## Supplemental Staff Report & Recommendations

### Sunrise Terrace Subdivision: Type III

### Preliminary Plat and SEPA DNS

(2014-006-SUB) October 16, 2015

**EXISTING CONDITIONS PEDESTRIAN  
SIDEWALK PATH TO SCHOOLS**

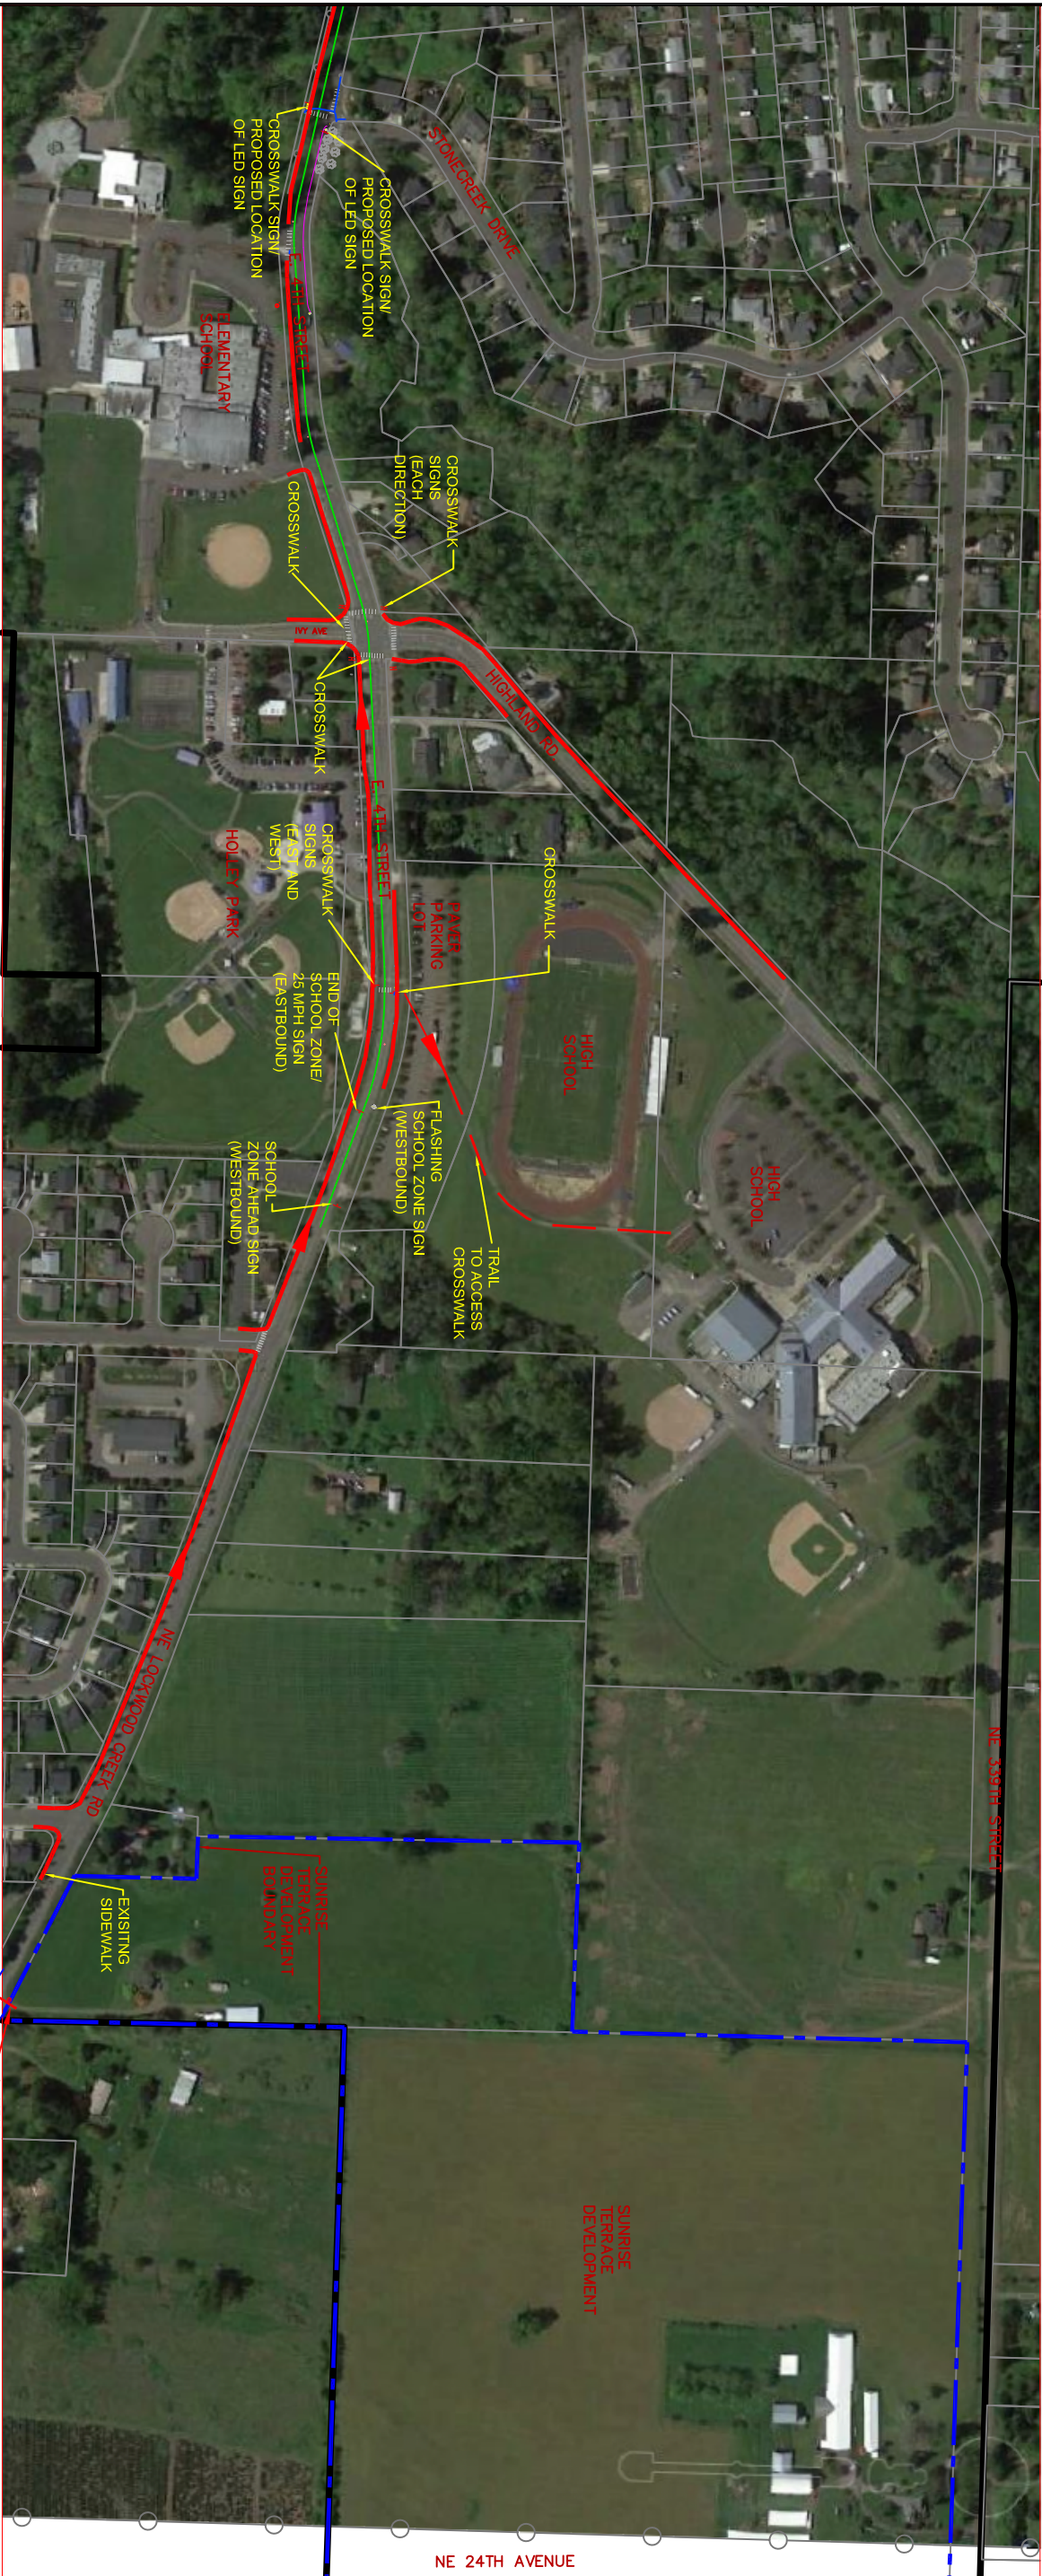
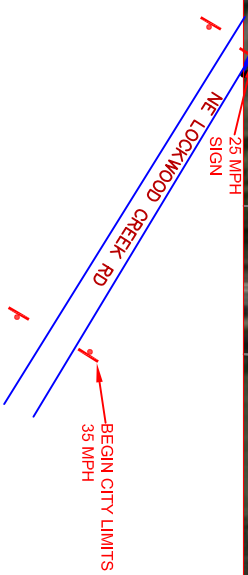
Attached is a City-generated exhibit which shows the location of existing sidewalks, pedestrian crossings and designated school zones between the Sunrise Terrace and the La Center Elementary, Middle and High Schools. This exhibit shows how children can use existing sidewalks and crossings to access schools. However, the City Engineer does not have sufficient information to determine whether Sunrise Terrace provides safe walking access to all La Center schools or whether mitigation is necessary to ensure safe access to school.

In the absence of express City policies or regulations on traffic or pedestrian safety the City relies on the Manual on Uniform Traffic Control Devices (MUTCD) for guidance. The MUTCD and Section 18.215, La Center Municipal Code authorizes the City to require an engineered traffic analysis. The MUTCD, Section 4C.06 Warrant 5, School Crossings, recommends that a traffic control signal shall be considered when an engineering study of the number of school children crossing a major street, such as Highland Road at 4<sup>th</sup> Street, and the volume of traffic exceeds the values listed in the MUTCD.

As a **Condition of Approval** prior to final plat approval the developer shall provide the City with an analysis of safe access to school to and from Sunrise Terrace and all La Center public schools; the analysis shall be performed by a traffic engineer licensed in the state of Washington and the analysis shall be based on MUTCD procedures and advisories and shall include the Highland and East 4<sup>th</sup> Street
